**LEBANON PLANNING BOARD
MAY 20, 2024 - 7:00 PM
COUNCIL CHAMBERS, CITY HALL OR
REMOTE VIA VIRTUAL PLATFORM
LEBANONNH.GOV/LIVE**

- B. **Dartmouth Hitchcock Medical Center, 1 Medical Center Drive (Tax Map 10, Lot 8), zoned MC:** Applicant requests a Site Plan amendment to expand and reconfigure four existing parking lots and to widen a driveway, together with associated site improvements. **PB2024-12-SPA**

DARTMOUTH-HITCHCOCK MEDICAL CENTER

MAIN CAMPUS PARKING EXPANSION

C209
Page 18 of 27

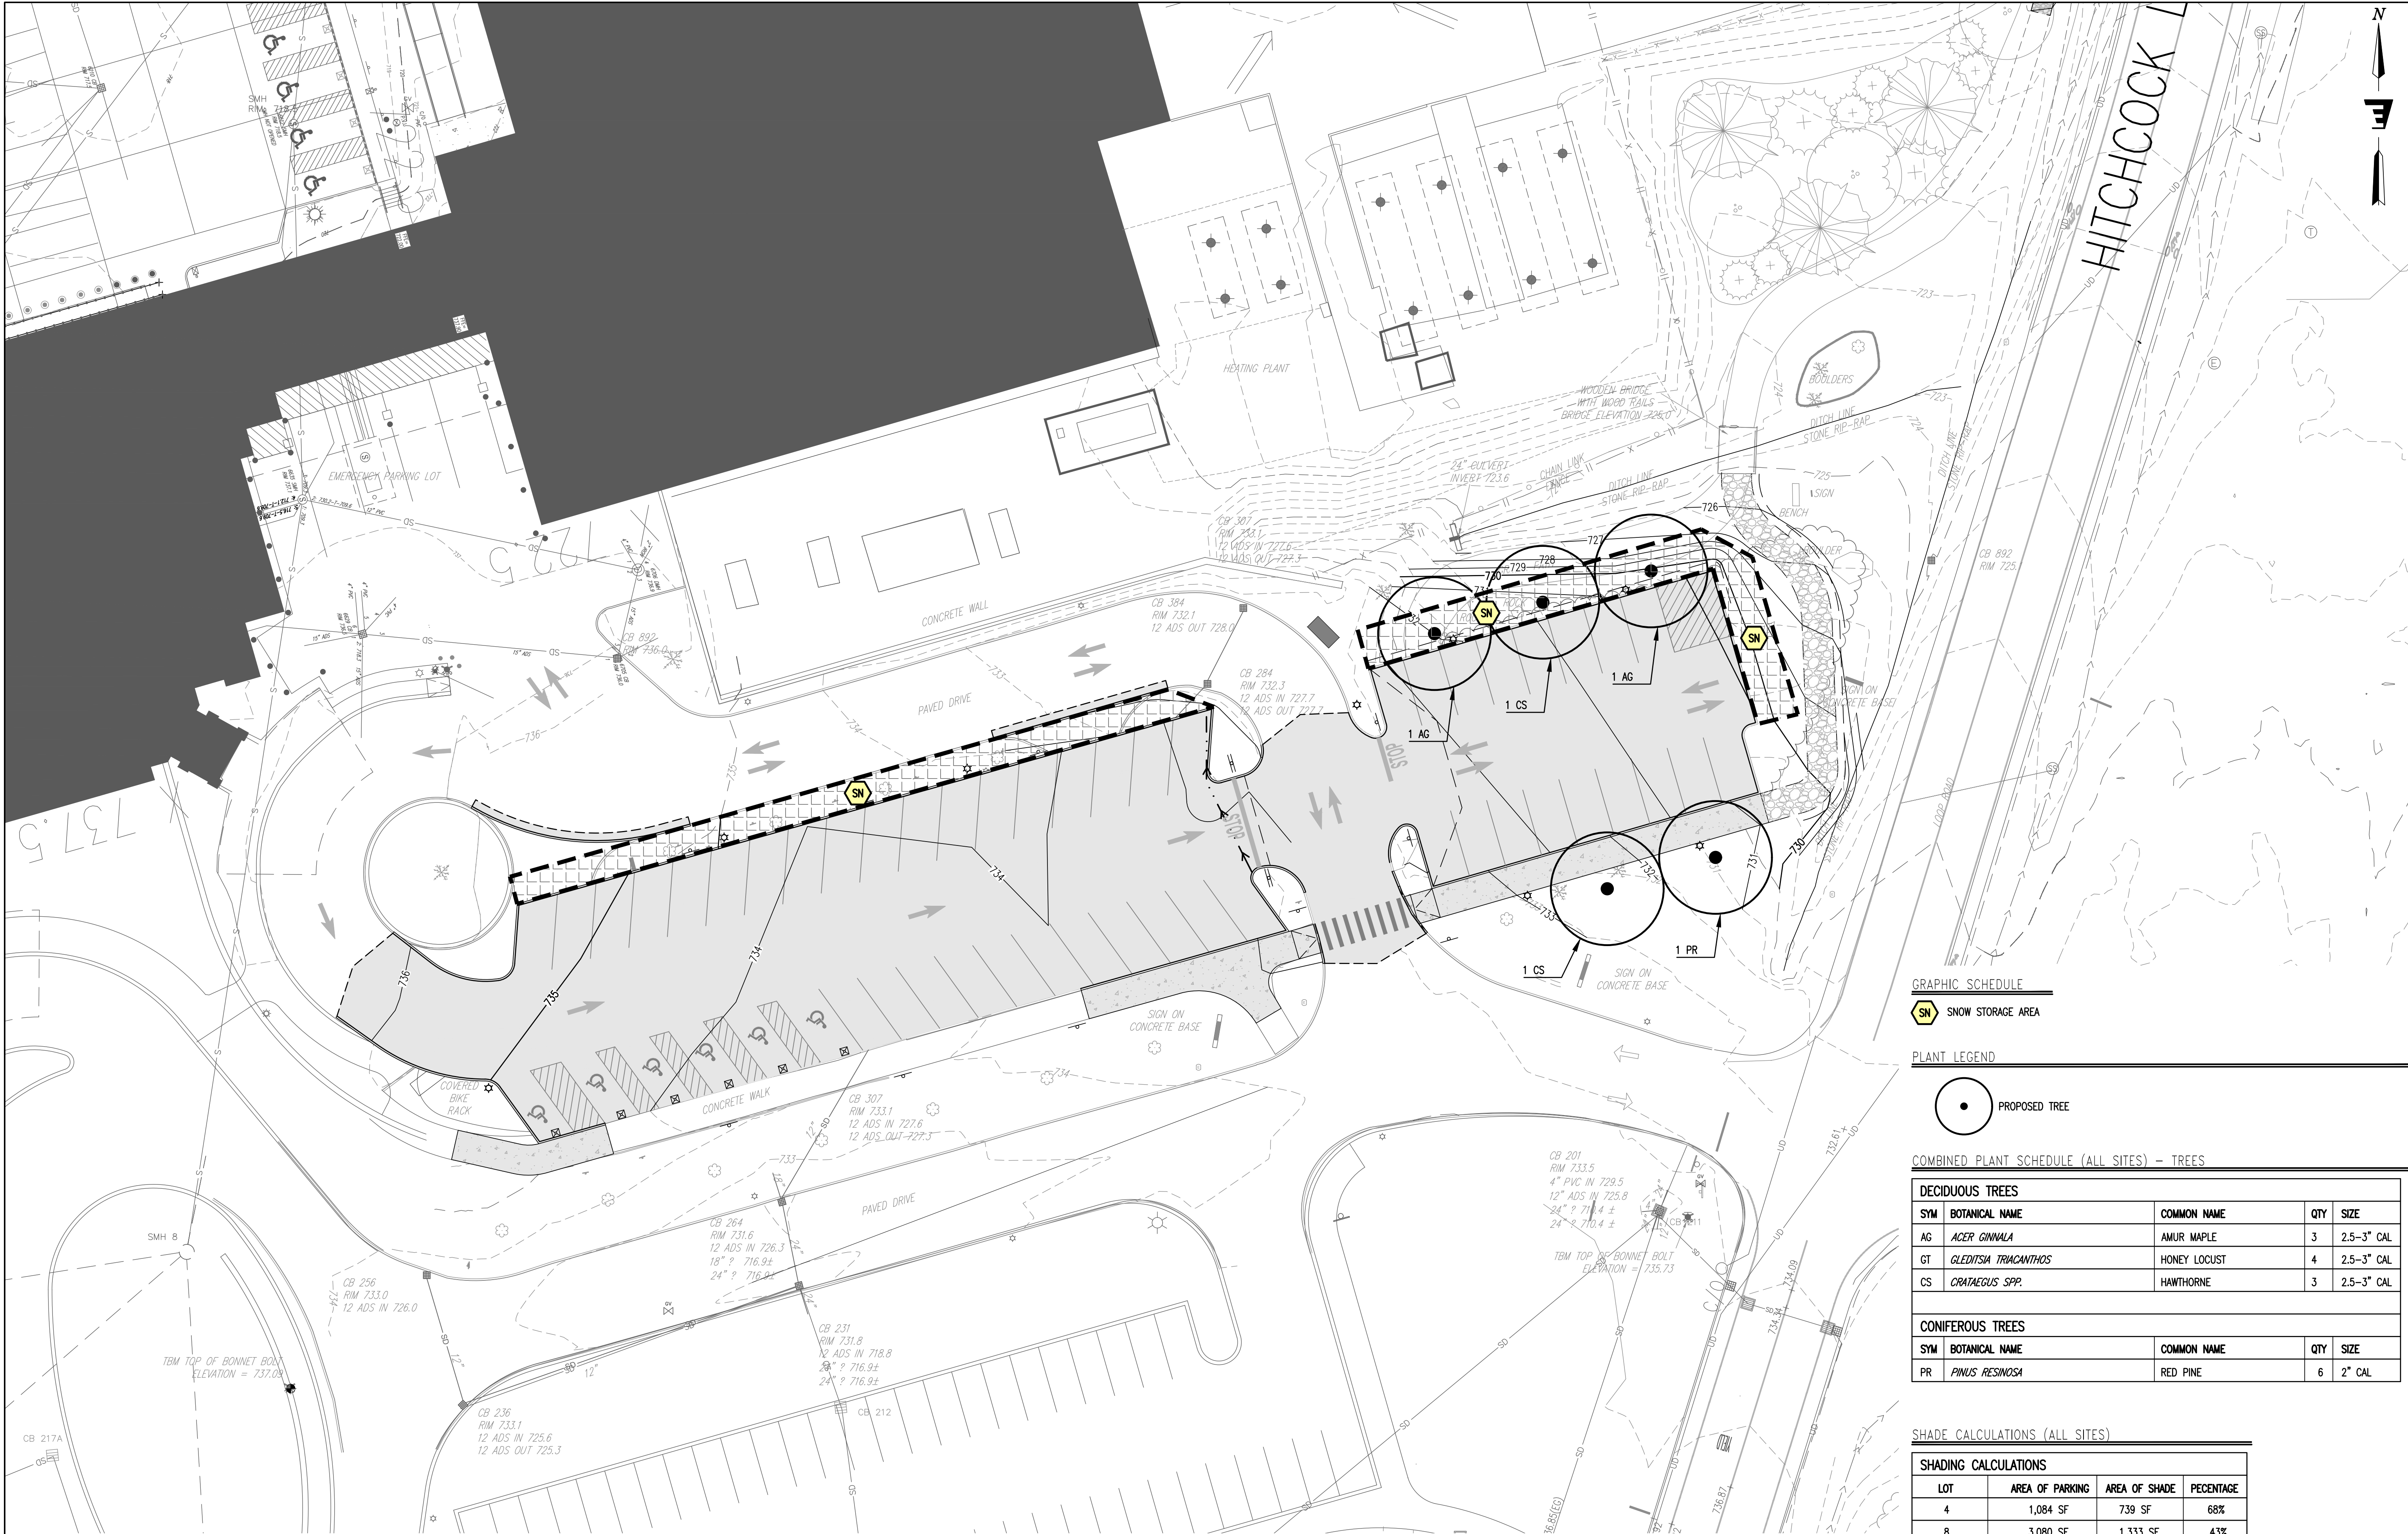
- **Sheet 18 (C209) –**
 - the plant schedule identifies 16 new plants where only 7 are shown
 - The schedule has been revised to clearly indicate schedule is a combination of all sites. This will make things easier for the contractor.

- parking lot shading calculations not provided
 - This sheet now includes a table showing shade calculations.
- **Sheet 19 (C210) –**
 - the plant schedule identifies 16 new plants where only 5 are shown
